BUCHER HYDRAULICS ELECTRONIC CARD ELEV-1 TO ELRV-1

SERVICE BULLETIN :

Product: Electronic card ELRV-1

1. Electronic Card ELRV-1 Identification

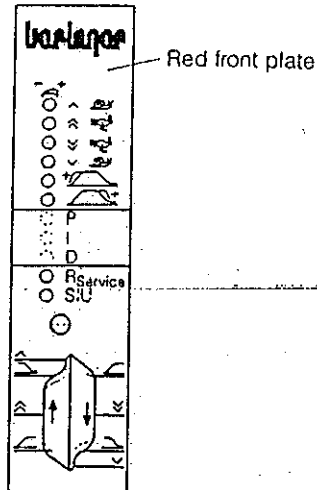
This concerns all ELRV-1 electronic cards supplied since 1997, which were installed according to our wiring diagram 2.1.20E. Visually these are recognizable by a red, plastic front plate. Attached you will find instructions for the modification, with which corrections at the connectors of the power module can be undertaken.

2. Inappropriate wiring of safety relay R1 at DOWN Solenoid

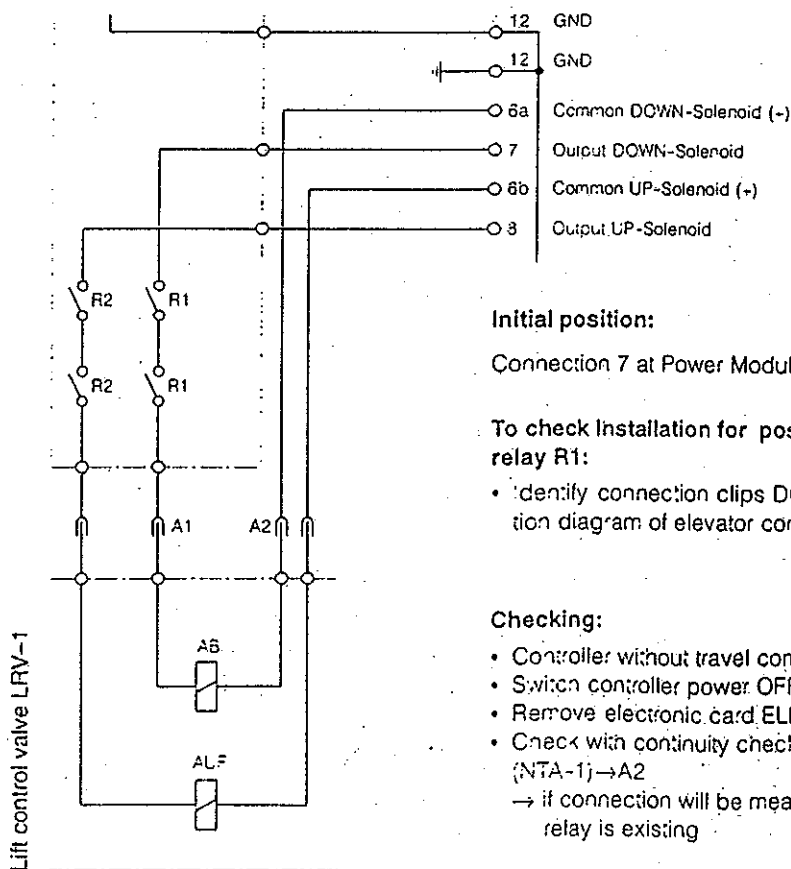
Initial position:

Connection 7 at Power Module NTA-1 leads to safety relay R1.

To check Installation for possible inappropriate wiring of safety relay R1:

- identify connection clips DOWN-Solenoid according to installation diagram of elevator controller (A1/A2 according to diagram)

- Controller without travel command / car at floor level
- Switch controller power OFF
- Remove electronic card ELRV-1 from power module
- Check with continuity checker or ohmmeter the connection 6a (NTA-1j) → A2
→ if connection will be measured, inappropriate wiring of safety relay is existing

3. Modified safer wiring of safety relay R1 at DOWN-Solenoid

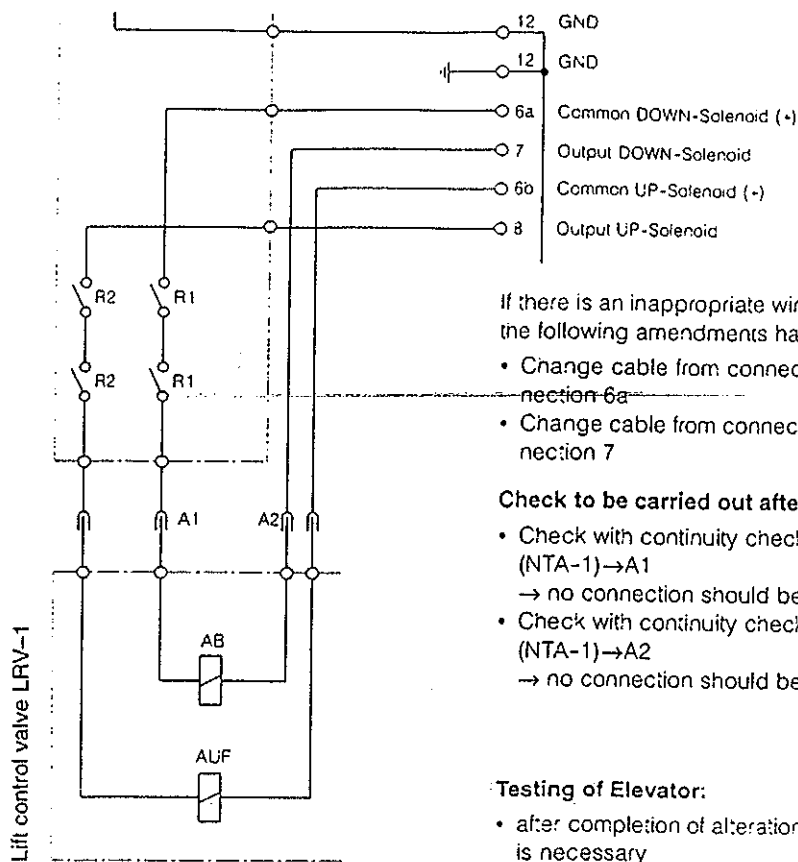
If there is an inappropriate wiring as described in point 2 (checking) the following amendments have to be done:

- Change cable from connection 7 at Power Module NTA-1 to connection 6a
- Change cable from connection 6a at Power Module NTA-1 to connection 7

- Check with continuity checker or ohmmeter the connection 6a (NTA-1)→A1
→ no connection should be measured
- Check with continuity checker or ohmmeter the connection 6a (NTA-1)→A2
→ no connection should be measured

Power supply unit connection with electronic card ELRV-1 / wiring

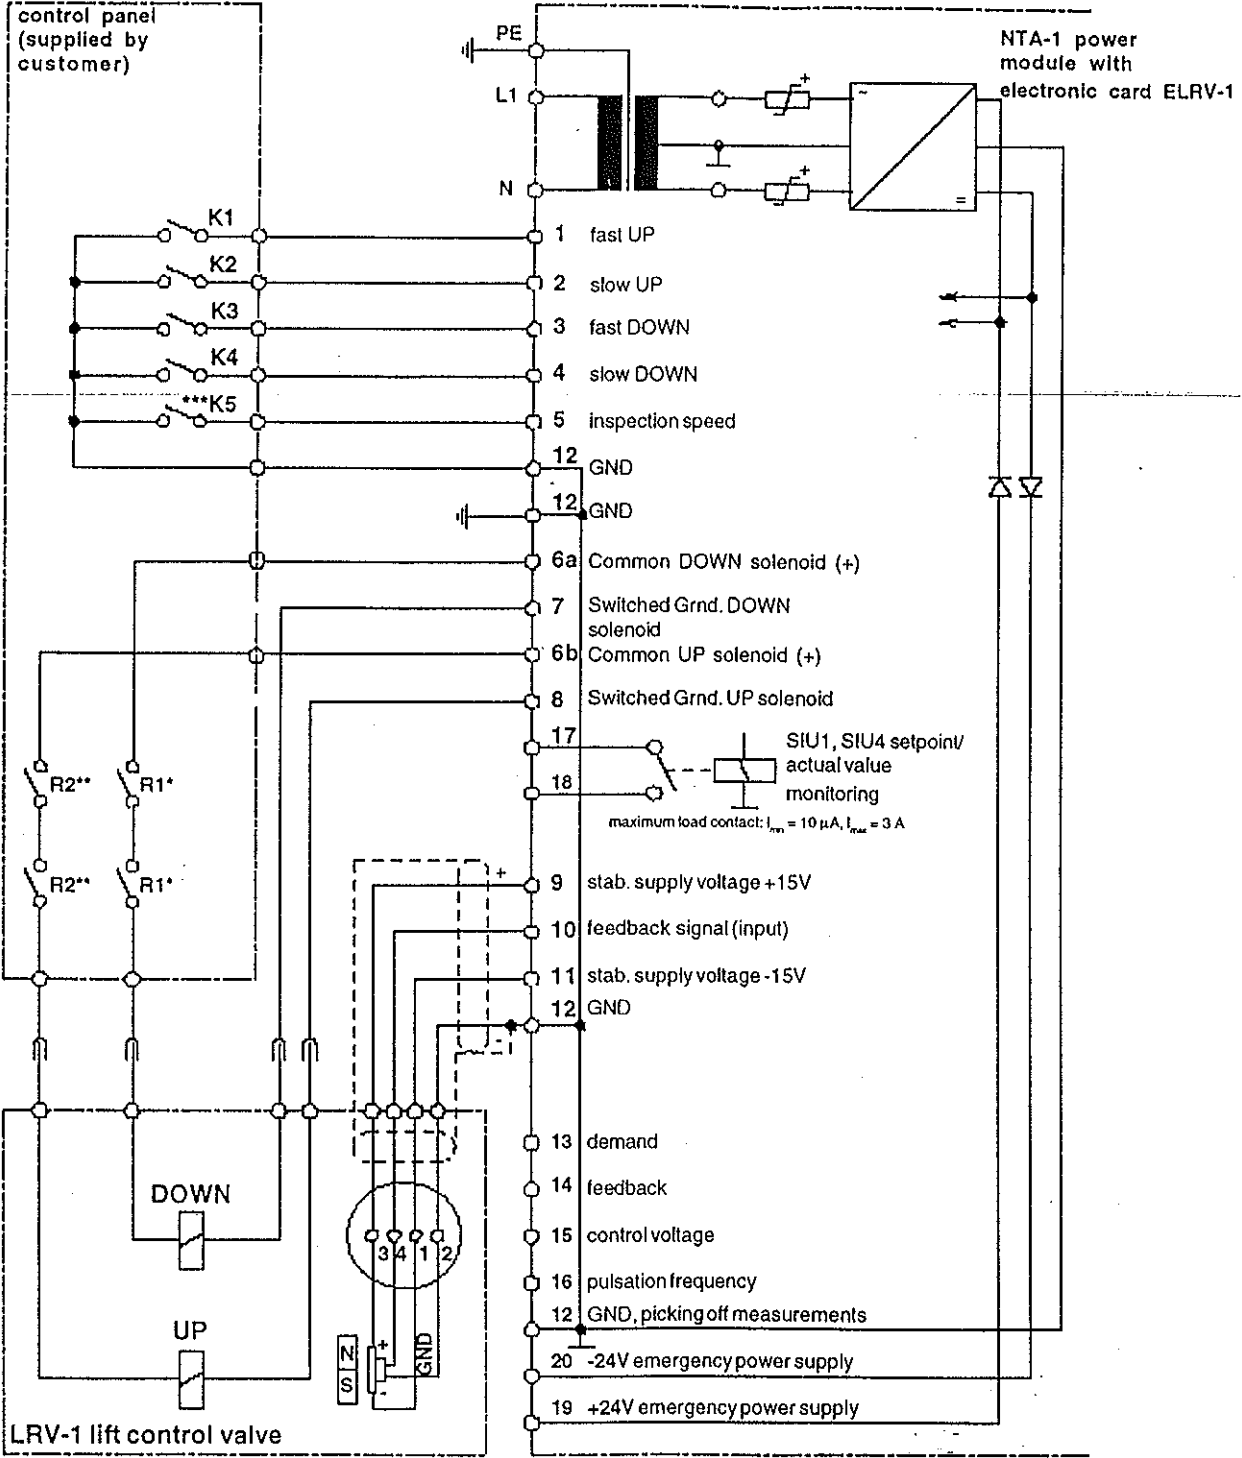
Correction

- * R1 "Safety relay DOWN", required twice acc. to TRA 262.2 and EN 81.2
- ** R2 "Safety relay UP", required twice acc. to EN 81.2
- *** When contact K5 is closed, all 4 speeds are reduced on the ELRV-1 to 12 - 80 % of rated speed depending on the setting of RService
